**MARION TOWNSHIP PLANNING COMMISSION
AGENDA**

RE: Howell Storage Expansion
Final Site Plan Review

Preliminary and Final Site Plan Review for Marion Township, Michigan

RE: Marion Oak Clubhouse
Site Plan Review

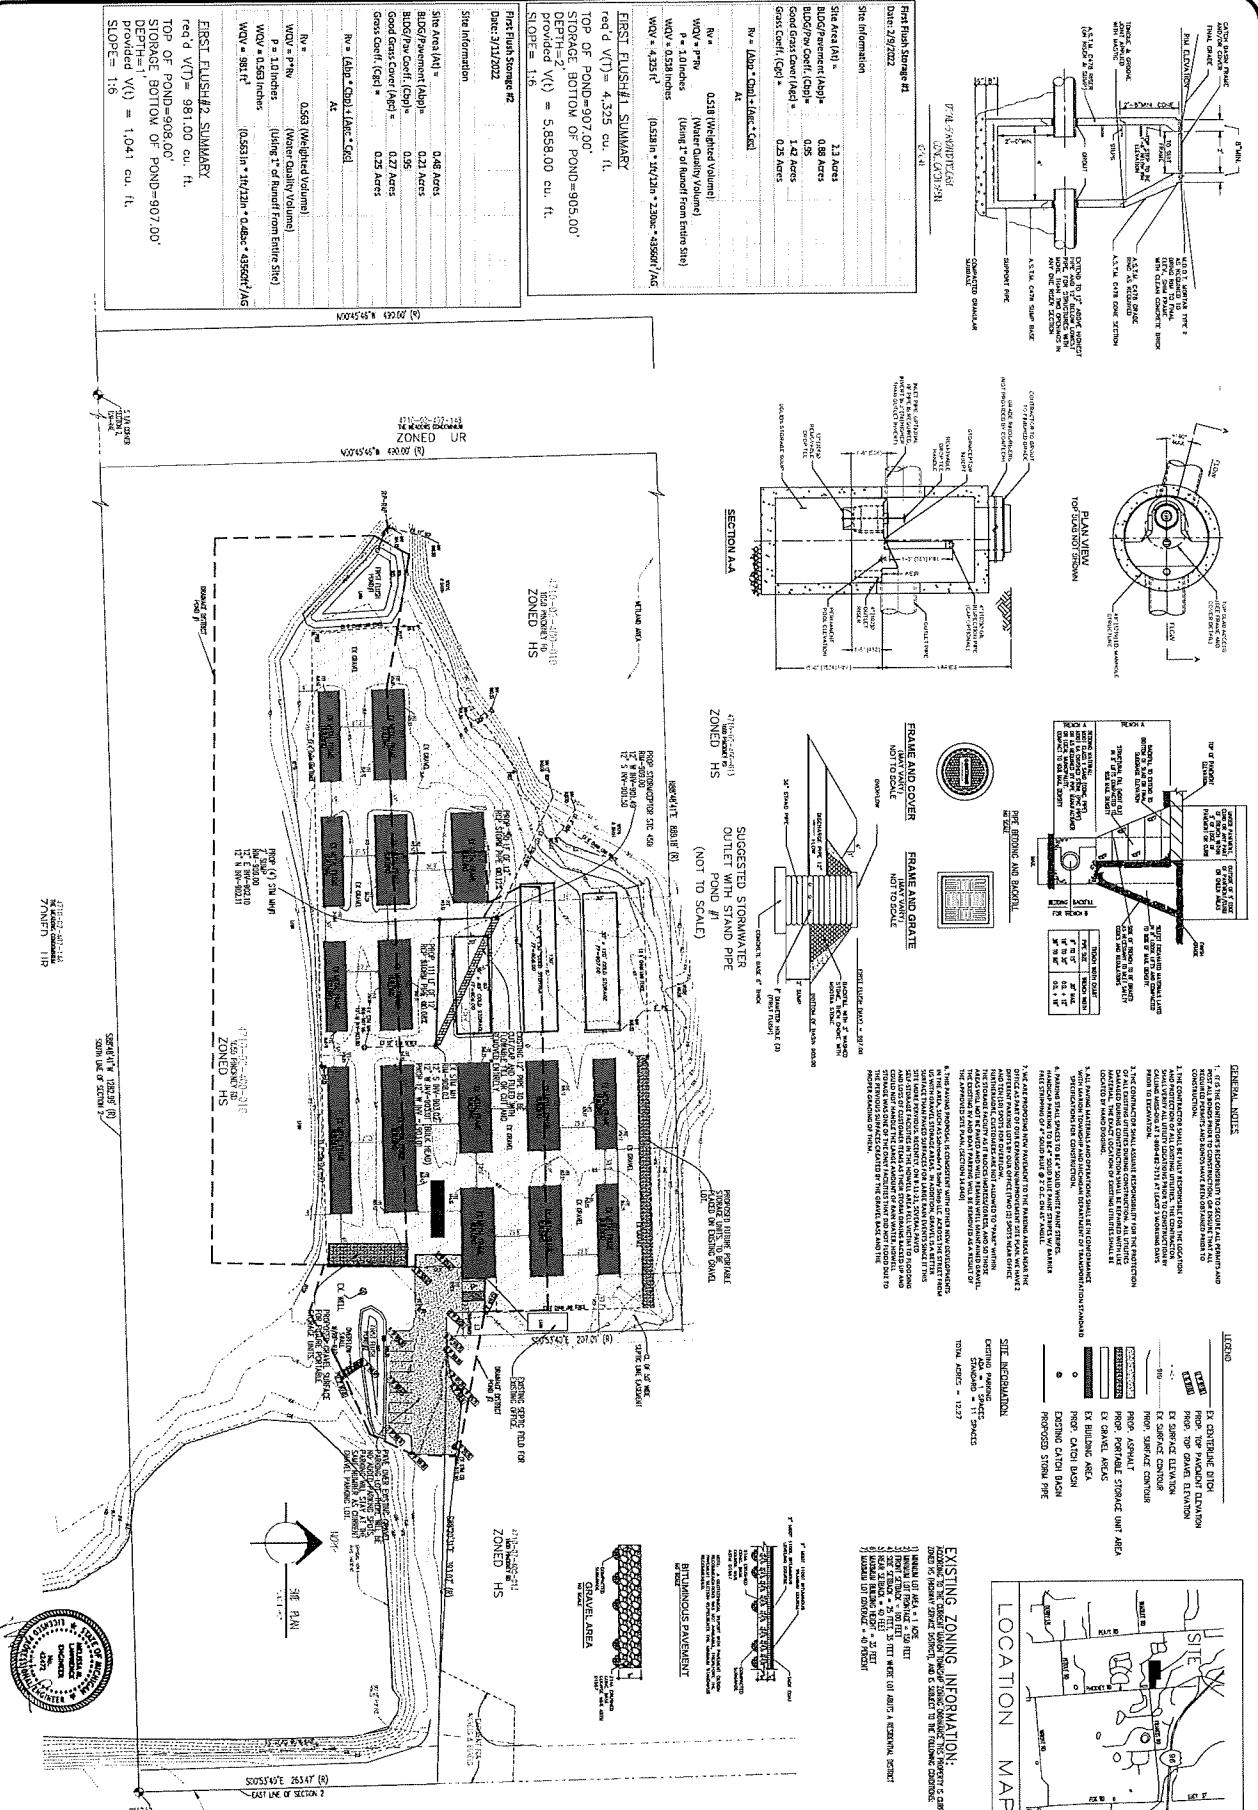
The concept for the first flush basins at both the front and the rear of the mini-storage looks workable. The first flush basins will improve the water quality associated with the discharges on the east and west of the project site.

I've attached sheet three through six of the plan set, though the bulk of my comments are on Sheet No. 3. I will have my soil erosion inspector Rod Soos review the SESC plan (Sheet 4) tomorrow and send you comments.

In addition to my redlined remarks, the plans should include a detail for rip-rap placed over keyed in geofabric associated with the following:

1. The swale downstream of the outlet pipe for first flush pond No. 1.
2. The overflow swale for first flush pond No. 2

SHEET TITLE:
LIGHTING PLAN

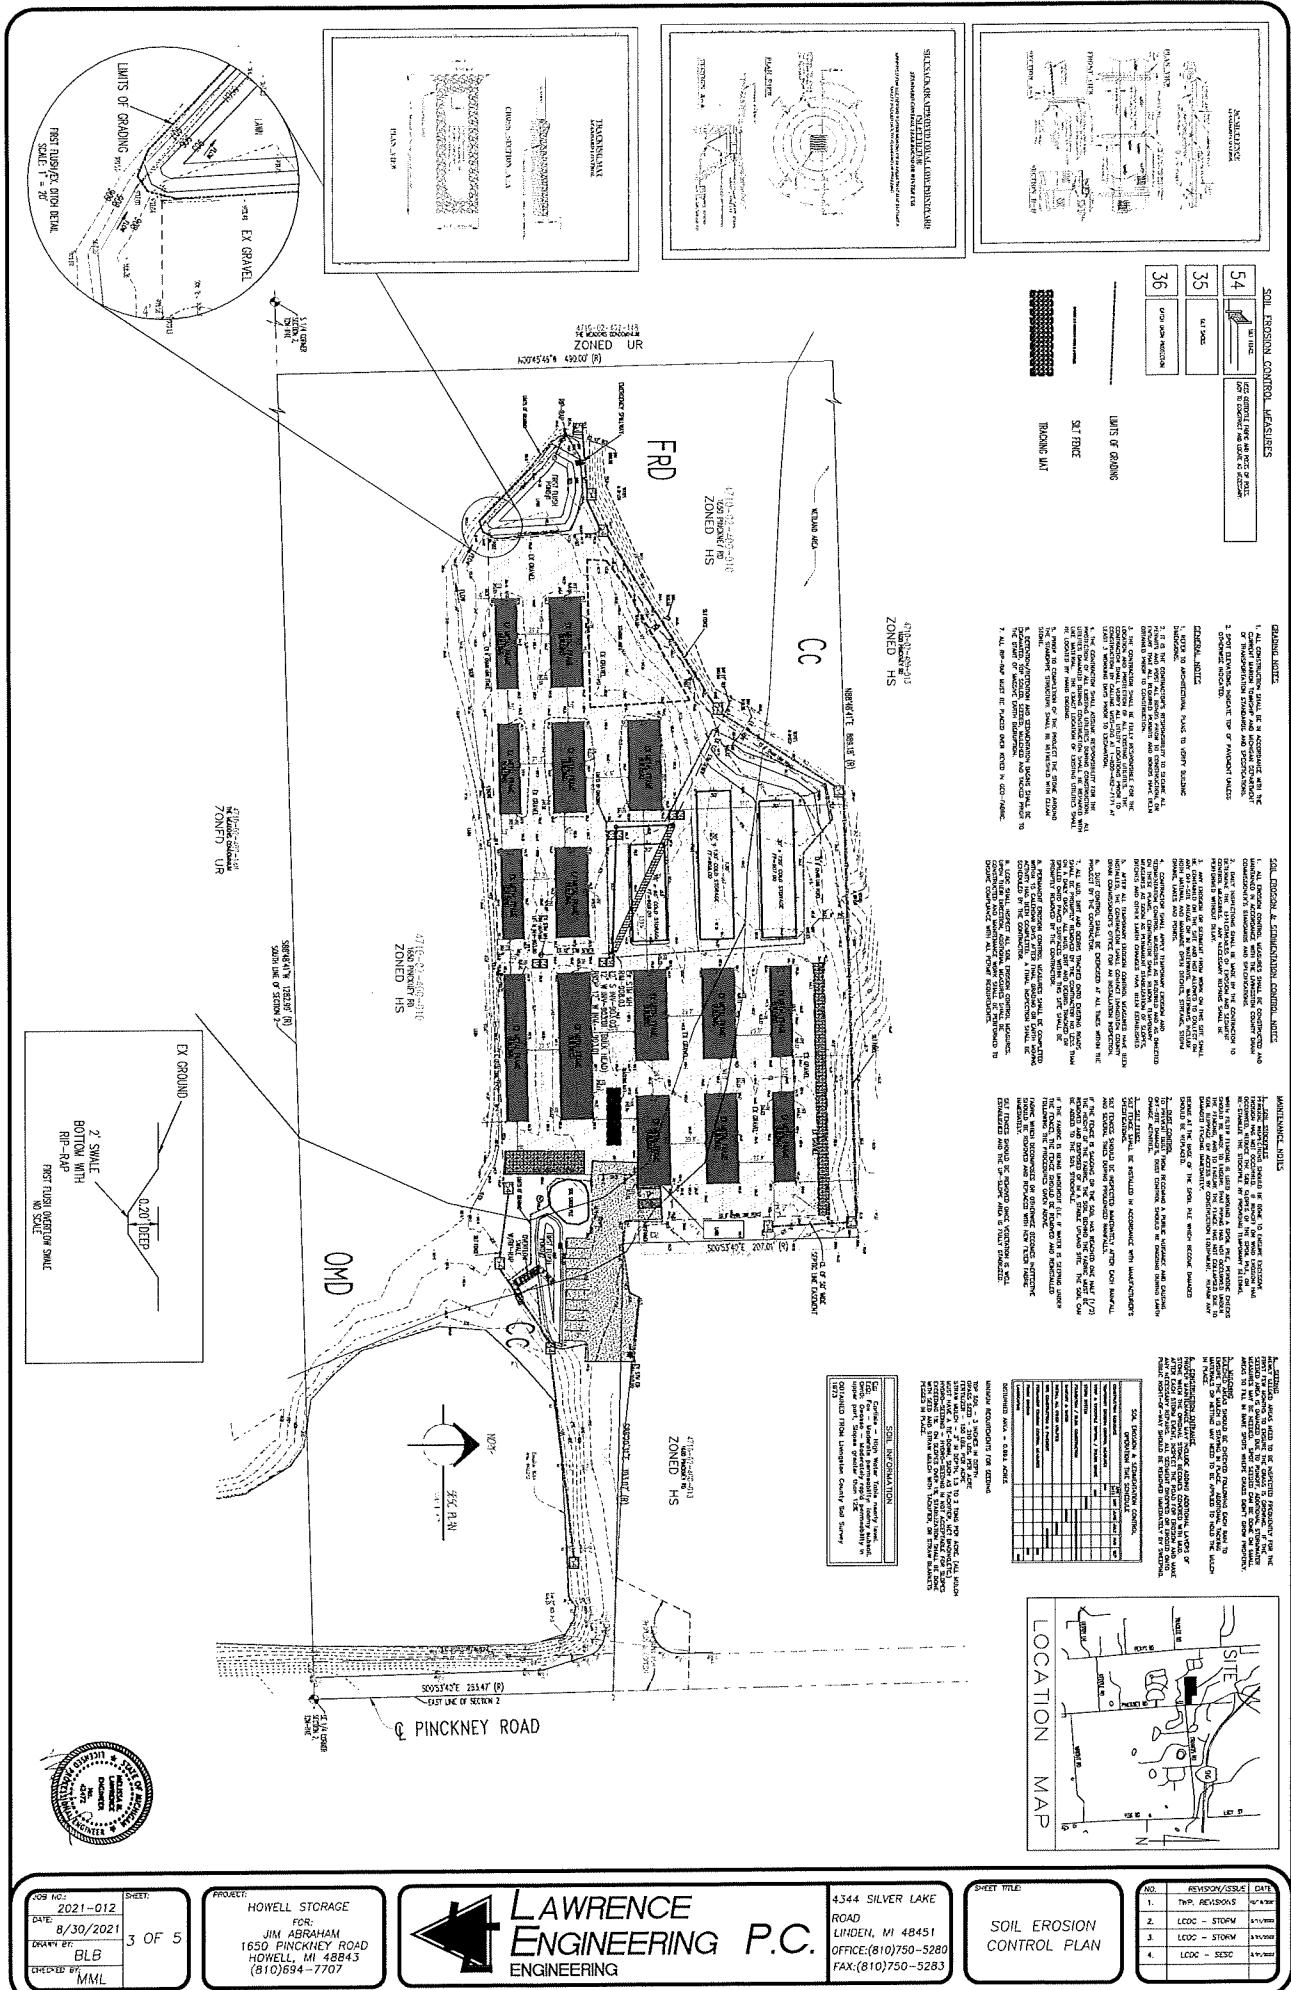
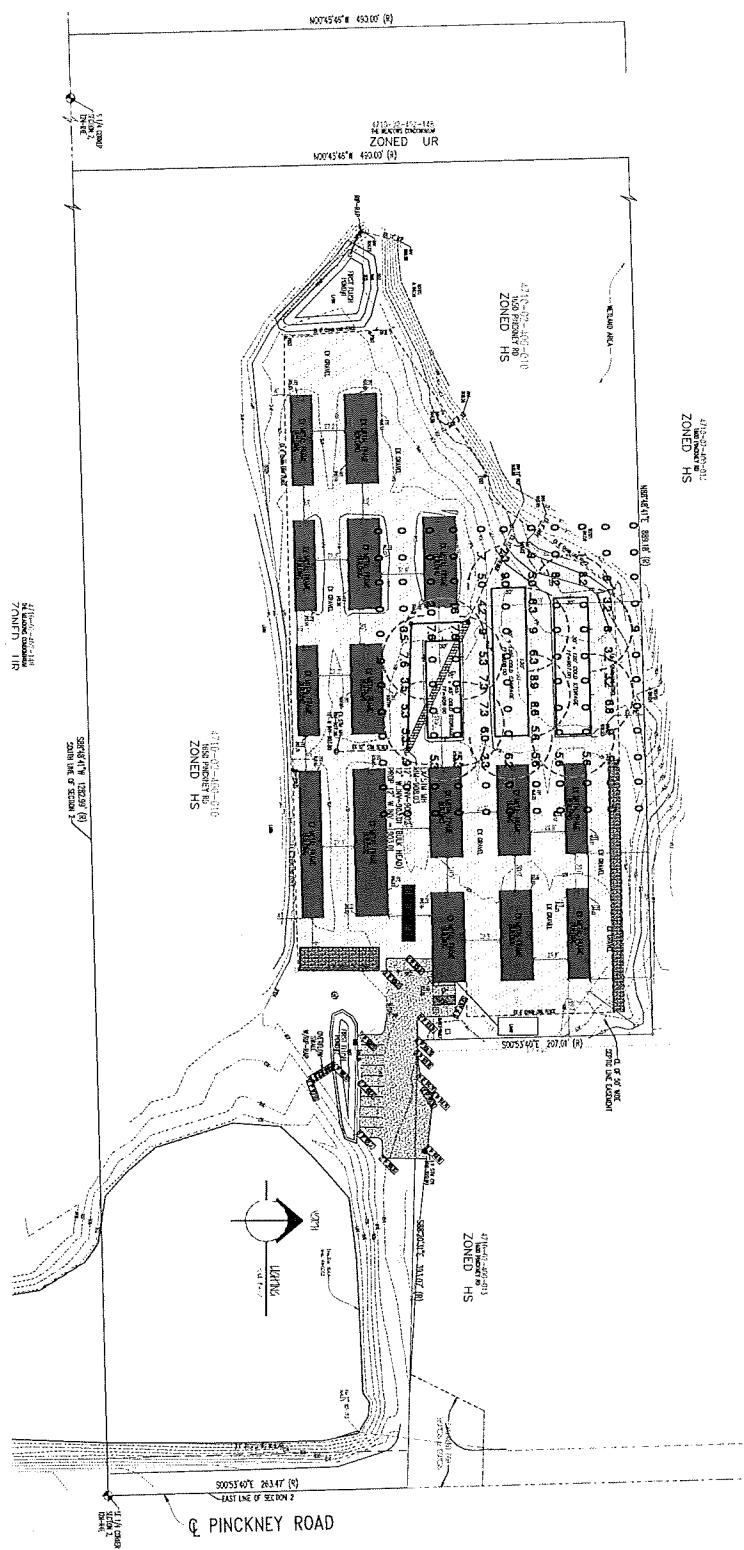
- 1) Clarify RV and boat storage areas.
- 2) Review and approval by Fire Department.
- 3) Review and approval of infrastructure needs by Township engineer.
- 4) Confirm need for Livingston County Drain approval.
- 5) Building lights should be down shielded and motion activated, if possible.

SP-11

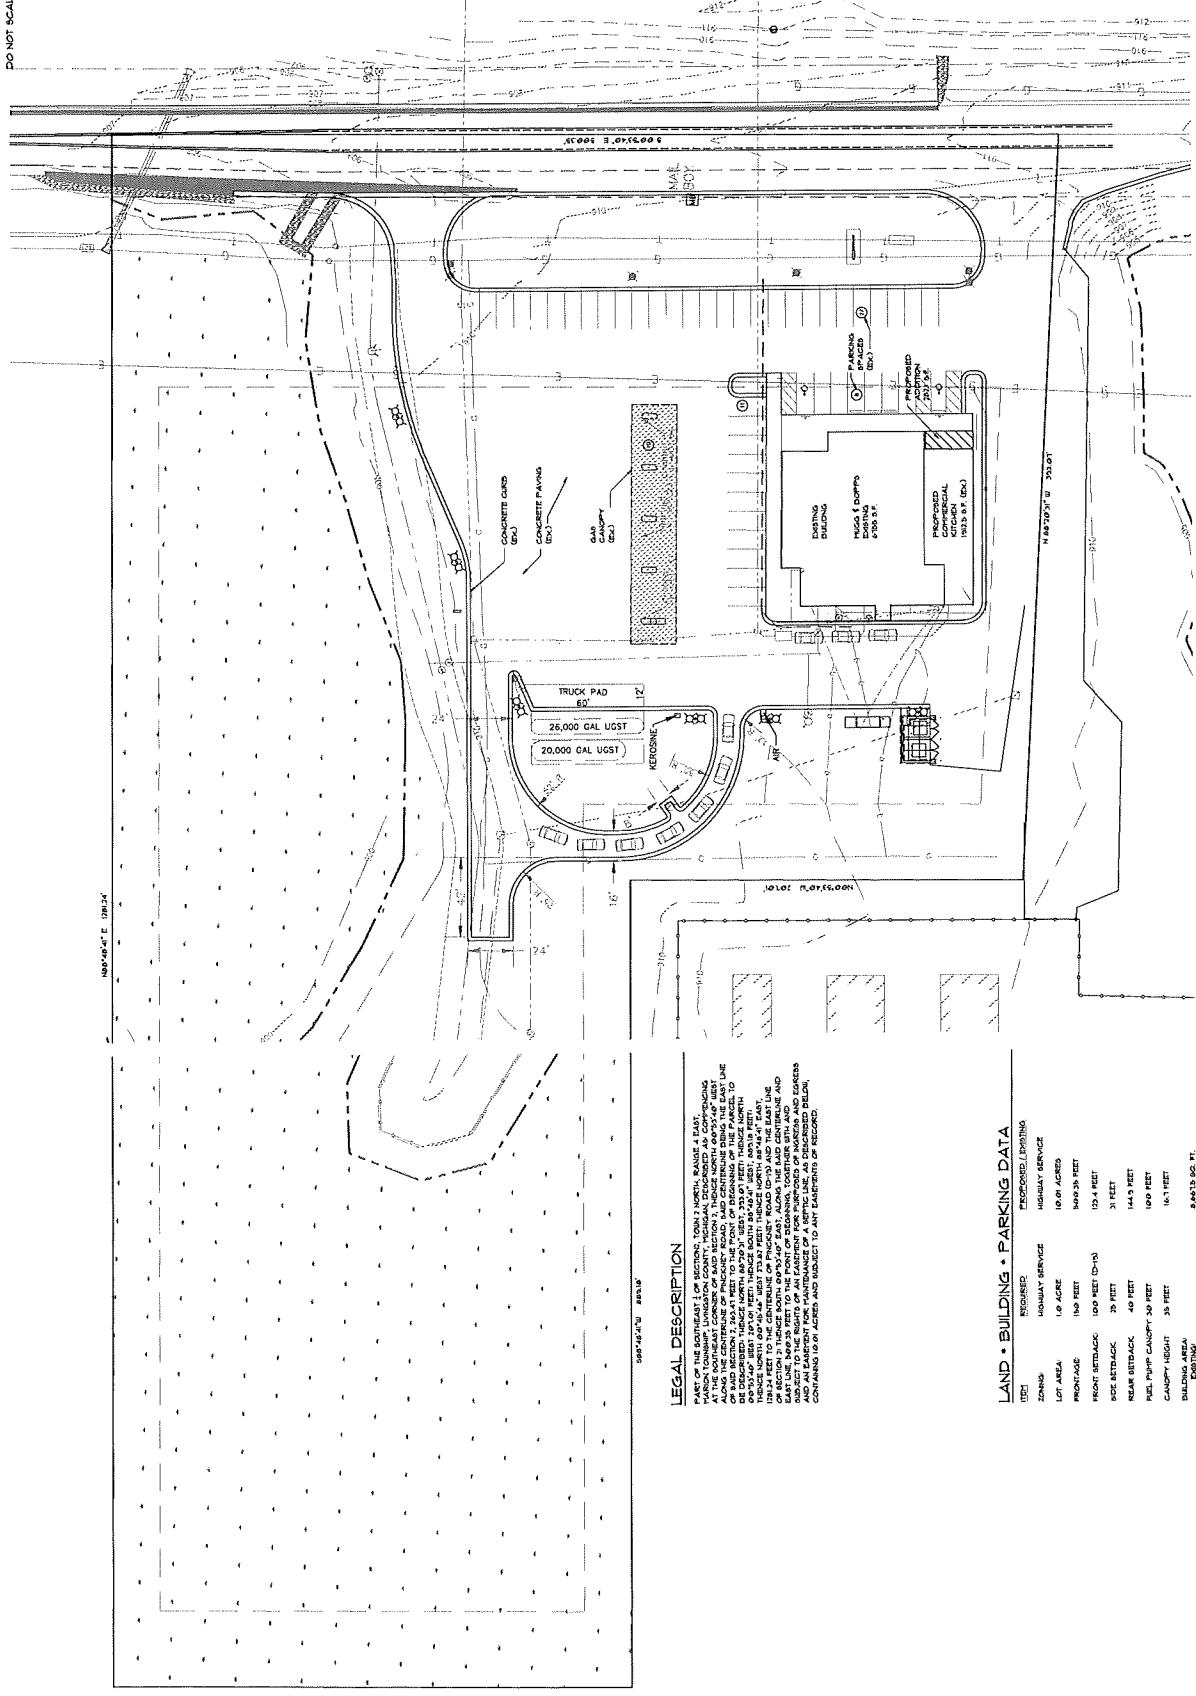
A table on Sheet SP-1.1 describes the proposed setbacks and other developmental standards. Setbacks are not dimensioned on the site plan.

Items to be Addressed: 1) Setbacks to the proposed addition shall be added to the site plan for administrative review. 2) Lot coverage, as a percentage of the lot area, shall be added to the site plan for administrative review.

As noted on Sheet SP-1.1, there are 56 parking spaces on the site, including 3 accessible spaces.

Utility locations are shown on the site plan, but they are not described in a legend.

Items to be Addressed: 1) A legend describing the utilities depicted on the site plan shall be added for administrative review. 2) Utilities and stormwater management approval by the Township Engineer.

Although described in a table on Sheet SP-1.1, the setbacks for the proposed addition are not dimensioned on the site plan. The site plan does not show the location of easements, including the road right-of-way.
